Docket Number:	18-AAER-02
Project Title:	Appliance Efficiency Standards Rulemaking for Portable Electric Spas and Battery Charger Systems
TN #:	224255
Document Title:	Final Express Terms for Portable Electric Spas and Battery Charger Systems
Description:	Final Express Terms for portable electric spas and battery charger systems appliance efficiency rulemaking
Filer:	Jessica Lopez
Organization:	California Energy Commission
Submitter Role:	Commission Staff
Submission Date:	7/23/2018 1:32:41 PM
Docketed Date:	7/23/2018

Portable Electric Spas and Battery Charger Systems
Appliance Efficiency Rulemaking
June 2018

California Code of Regulations
Title 20. Public Utilities and Energy
Division 2. State Energy Resources Conservation and Development Commission
Chapter 4. Energy Conservation
Article 4. Appliance Efficiency Regulations

Figure 1. Label Design

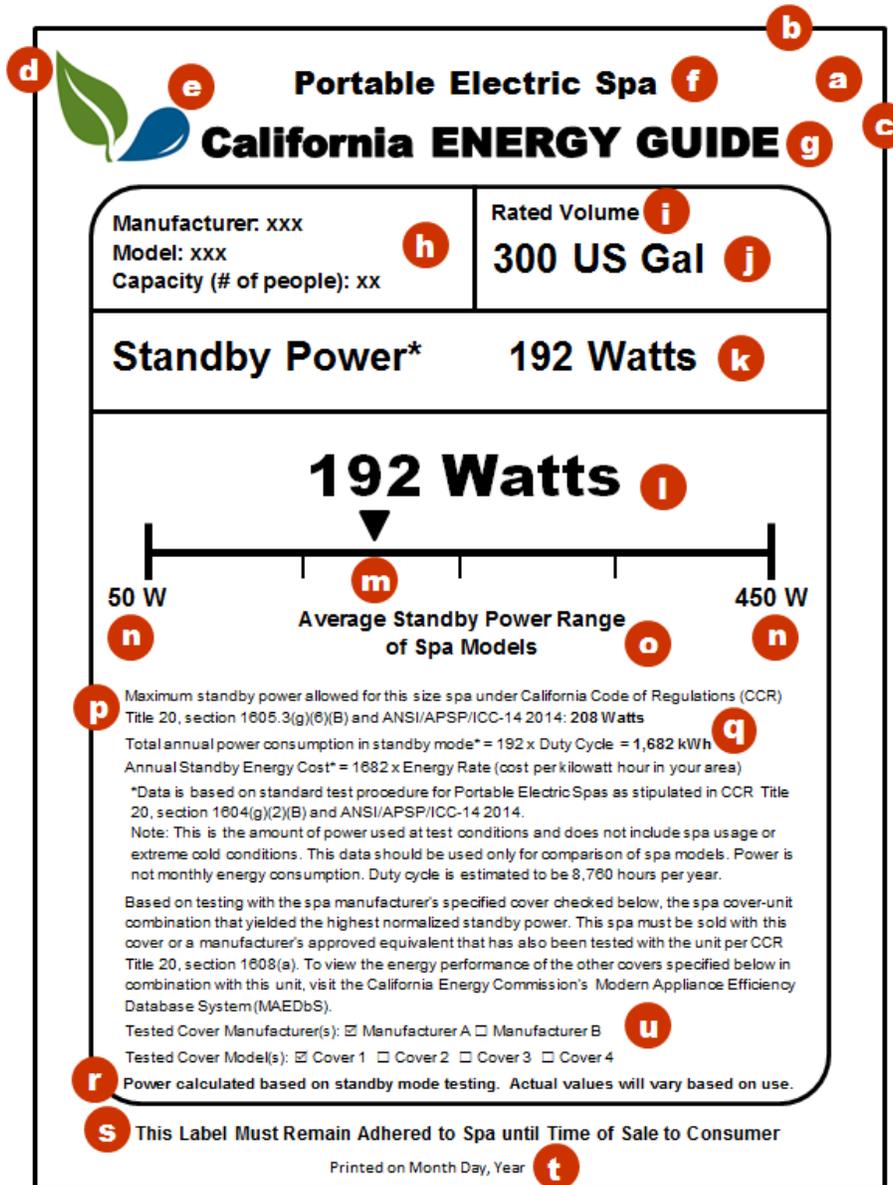
1. Label Specifications. The label shall be formatted as shown in Figure 1 and as directed in subdivision (d)(14)(B)2. of this section.

2. Letter Codes for Figure 1 Label Design. Letter codes for Figure 1 above:

a. Shall be printed on a white label with black text.

- b. Minimum label width: 5 inches.
- c. Minimum label height: 6.25 inches.
- d. Leaf color: equivalent to Pantone 363 green (also permitted to be black).

- e. Water drop color: equivalent to Pantone 7691 blue (also permitted to be black).
- f. Font: Helvetica Neue Black; character height shall not be less than 15 point type. For standard spas, inflatable spas, and the standard spa portion of combination spas the text shall state the following: Portable Electric Spa. For exercise spas and the exercise spa portion of combination spas, the text shall state the following: Exercise Spa.

- g. Font: Helvetica Neue Black; character height shall not be less than 24 point type. Text shall state the following: California ENERGY GUIDE.
- h. Font: Arial Bold; character height shall not be less than 9.5 point type. Text shall state the following:
Manufacturer: [insert name of manufacturer here]
Model: [insert model number here]
Capacity (# of people): [insert number of people here].

- i. Font: Arial Bold; character height shall not be less than 9.5 point type. Text shall state the following: Rated Volume.
- j. Font: Arial Bold; character height shall not be less than 16 point type. The text shall state the value of the rated volume in U.S. gallons and shall state the units of the rated volume as follows: US Gal.

- k. Font: Arial Bold; character height shall not be less than 16 point type. The text shall state the following: Standby Power* [insert the normalized standby power value resulting from the test in watts here, rounded to a whole number] Watts.

- l. Font: Helvetica Neue Black; character height shall not be less than 24 point type. The text shall state the normalized standby power value resulting from the test in Watts, rounded to a whole number, and shall state the units of the tested standby power.

- m. The standby power chart arrow shall be scaled at the appropriate location between the minimum and maximum power range using the normalized standby power test result value for the spa which is being installed. The

minimum standby power shall be 50 watts, and the maximum standby power shall be 450 watts for standard spas, inflatable spas, and the standard spa portion of combination spas. The minimum standby power shall be 100 watts and the maximum standby power shall be 750 watts for exercise spas and the exercise spa portion of combination spas. If the normalized standby power test result is outside the power range, add or subtract, in increments of 50 watts, from the minimum or maximum power range values, until the normalized standby power test result is within the power range and update the minimum or maximum power range values on the label.
